F07A/0075 /ADD. INFO

Re: Additional Information
Planning Ref No: F07A/0075
Decision Order No. 0933 dated 16th March 2007

**POTENTIAL IMPACTS OF MAJOR ACCIDENT HAZARDS
ASSOCIATED WITH THE PROPOSED NEW 5 NO.
VERTICAL ATMOSPHERIC 50 M³ STAINLESS STEEL
TANKS FOR WASTE SOLVENT STORAGE IN THE
SOLVENT TANK FARM AT SWORDS LABORATORIES
(REPORT UPDATED IN RESPONSE TO HSA MEETING ON
SITE ON 28/2/07 AND FINGAL COUNTY COUNCIL
REQUEST FOR ADDITIONAL INFORMATION F07A/0075**

TITLE
PROPOSED MODIFICATION TO SITE DRAINAGE
TO PICK UP OVERSPILL FROM TANK FARM BUND

Figure 4.3 Impact of explosion for existing tank at northern end of bund

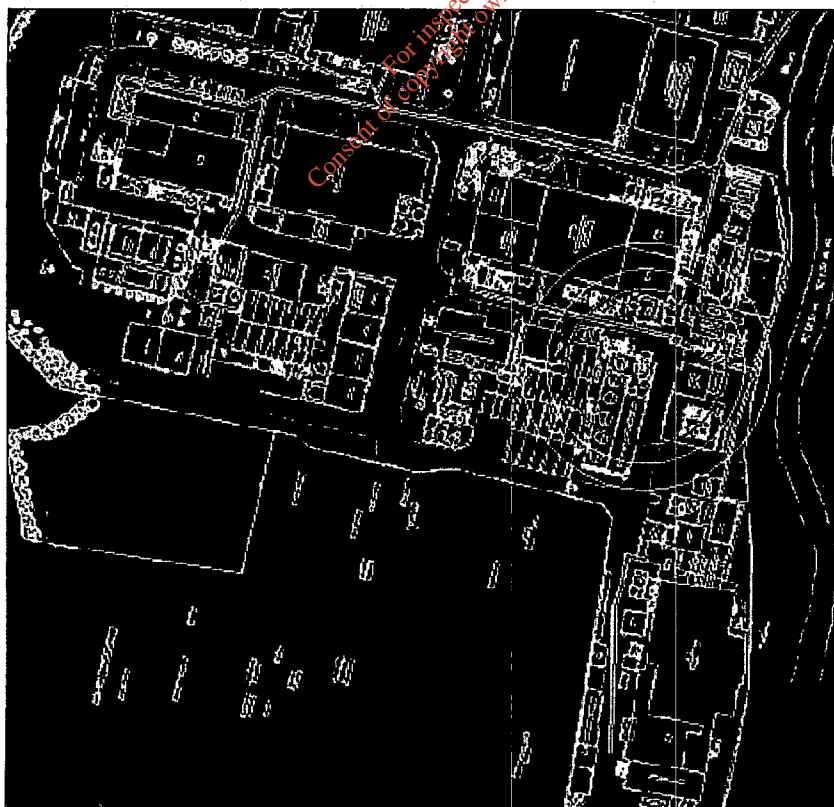
"the full extent and nature of the likely impact on this area with particular regard to its increased use as a public amenity";

It can be seen from Figure 4.3 that the existing impact is practically identical to the predicted impact with the proposed waste solvent tanks in place, in that the impact is on the steep river bank immediately adjacent to the Swords Laboratories site, which, as has been previously stated is a vertical/1:1 slope and is on the opposite side of the river from the existing Park.

In summary, the addition of the new solvent waste tanks does not change in any significant way the existing impact of the Swords Laboratories site, with respect to explosion impacts.

It is important to note that the impacted area adjacent to the site boundary is inaccessible and will not be frequented by members of the public. Therefore, there will be no change to the potential for public amenity use of the Park, as a result of the installation of the proposed waste solvent tanks.

Figure 4.6 Ground levels in vicinity of bund in which proposed tanks will be located

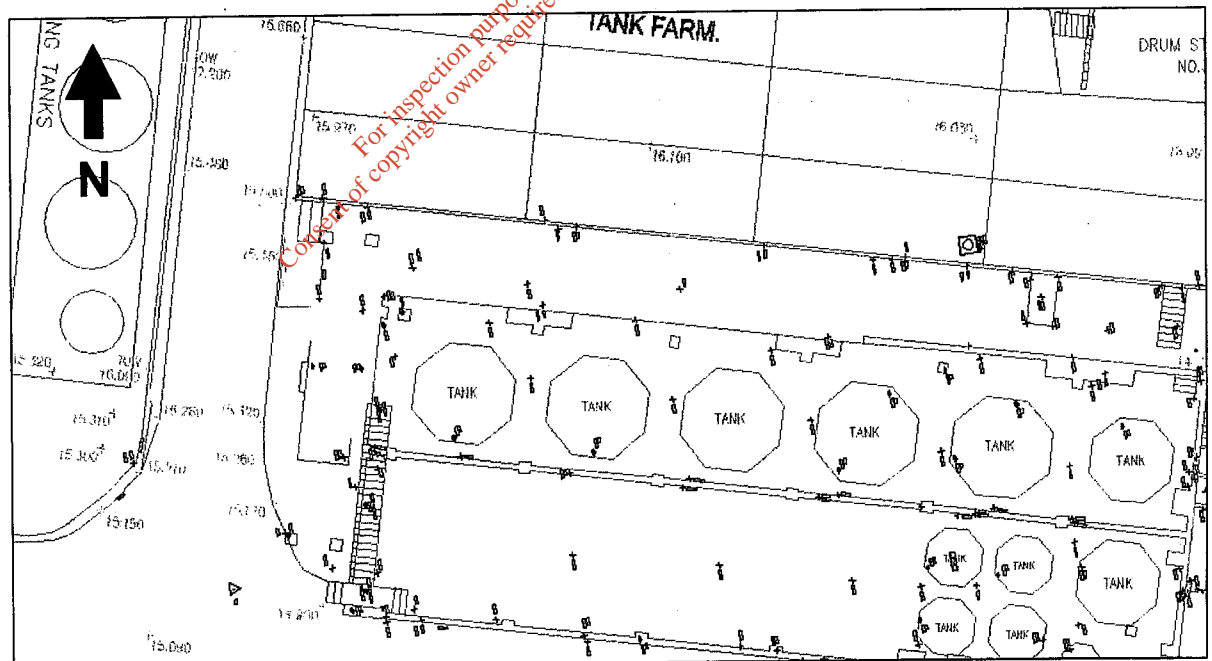
- In regard to the requirements of the Health and Safety Authority, the applicant is requested to submit a written assessment of the likelihood and consequences of a catastrophic loss of containment of a dangerous substance from the proposed tanks, with particular focus on any possible impact, i.e. bund overtopping as a major accident hazard scenario

It can be seen from Figure 4.6 that ground levels along the surface of the site road to the north and west of the bund begin at 15.66m AOD to the north and decrease to 15.48 m AOD, and then to 14.9 – 15.0m AOD, at the south western corner of the bund. It can therefore be seen that there is a fall on the road surface of some 0.5m as one moves from the north western corner of the bund to the south western corner
